Addendum No. 1

Owner: City of Unalaska

Project: **LEAR ROAD DUPLEXES KITCHEN AND BATH RENOVATIONS**
DPW Project No. 18201

Date: March 29, 2019

PROJECT MANUAL, Attachment D, Plan Sheet A4.1:

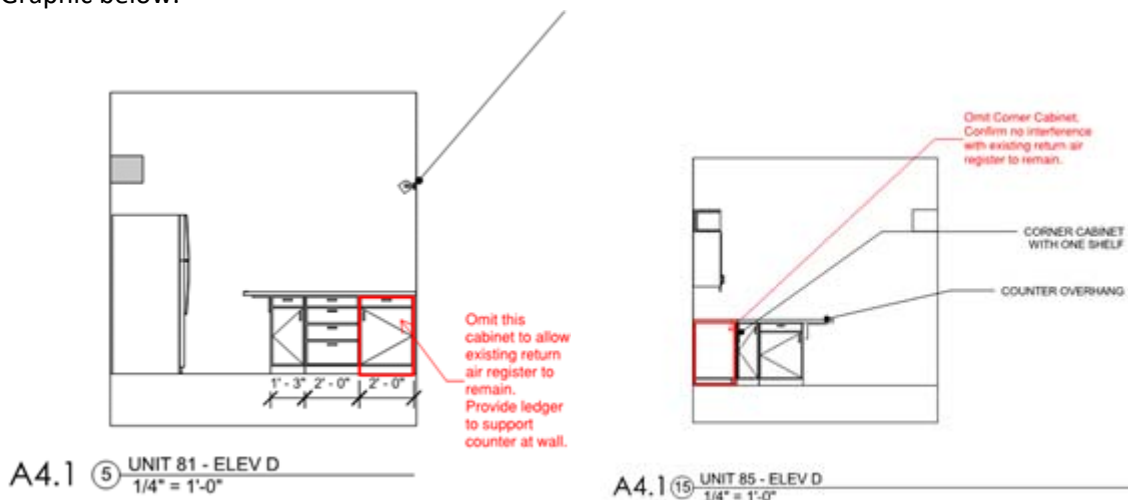
1. On **Detail 5 on sheet A4.1 (Unit 81)** remove one cabinet closest to the wall to maintain airflow to the existing register.
2. On **Detail 15 on sheet A4.1 (Unit 85)** remove the cabinet closest to the wall to maintain airflow to the existing register.

DRAWING A

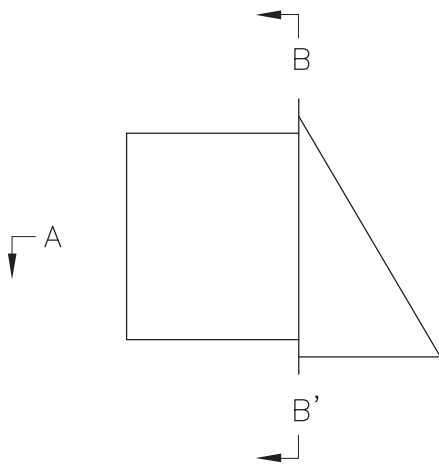
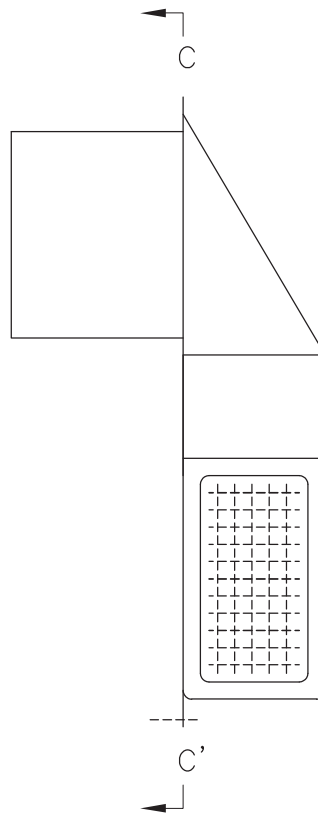
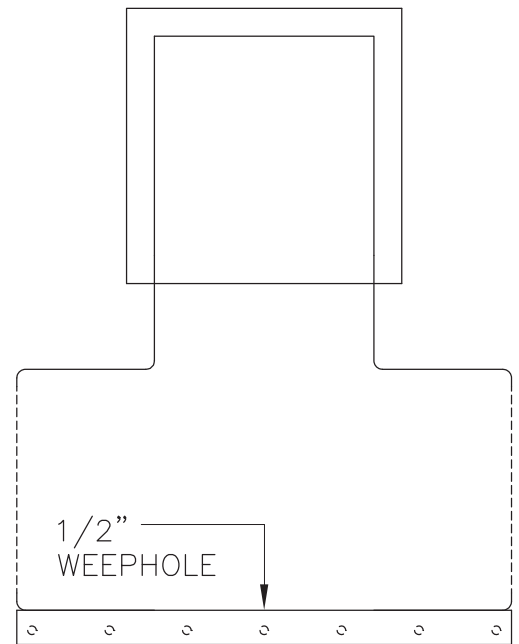
Keynote Legend Item 15: "EXHAUST FAN ARCTIC VENT WITH WALL COVER: Luxury Metals Wind Defender Energy Saver modified with arctic tee per attached City of Unalaska Details. SEE APPENDIX DRAWING A"

DRAWING A was not included in the Contract Documents. It is included in this addendum.

Add the Attached DRAWING A to Appendix D.

1. WALL VENT IS 6" LUXURY METALS LM WIND DEFENDER. 304B 26 GA STAINLESS STEEL WITH SPRING LOAD DAMPER, WEATHER SEAL AND SCREEN
2. SHOP FABRICATE ARCTIC HOOD FROM SAME MATERIAL AND WELD TO WALL VENT USING 1/2" TAB OVERLAP
3. CUT RELIEF NOTCHES, FOLD RADIUS AND TABS AND ADD CUT ANGLES AS NEEDED. NO SHARP EDGES
4. SIDE VENTS ARE 1/2" T304 STAINLESS STEEL 0.063" DIAMETER MESH
5. MAKE WEATHER TIGHT. SEAL WALL VENT COLLAR TO SHROUD WITH BUTYL RUBBER SEALANT
